# Service Bulletin

Bulletin No.: PIP5122

**Subject:** Pop Noise From Fuel Tank After a Cold Start Or EVAP Purge Event (Equinox / Terrain)

**Models:** 2010 -2014 Chevrolet Equinox  
2010-2014 GMC Terrain

3460471

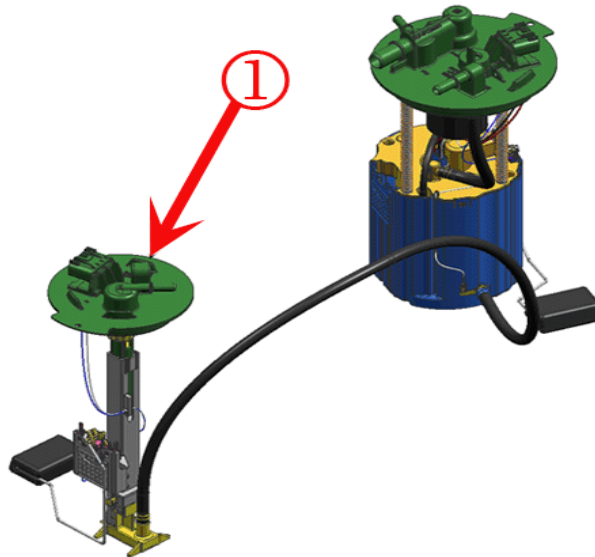
The technician should be able to duplicate the concern by commanding a purge and seal on the EVAP system using GDS2. As the vacuum reaches 3 to 5 inches, the pop/popping noise should be duplicated. The cause for this concern is the auxiliary fuel module in the left side of the fuel tank changing height (spring loaded leg) as the fuel tank collapses slightly.

The part number on the box of the auxiliary fuel module has not changed but the auxiliary fuel module inside of the box has. After ordering the auxiliary fuel module, remove it from the box and verify the flange (indicated in the picture below by "1") of the auxiliary fuel module where the spring loaded "leg" fits into, is either light green or light orange in color. This is the revised auxiliary fuel module designed to correct the pop/popping noise. The original auxiliary fuel module has a flange that is white in color.

(1) Flange location
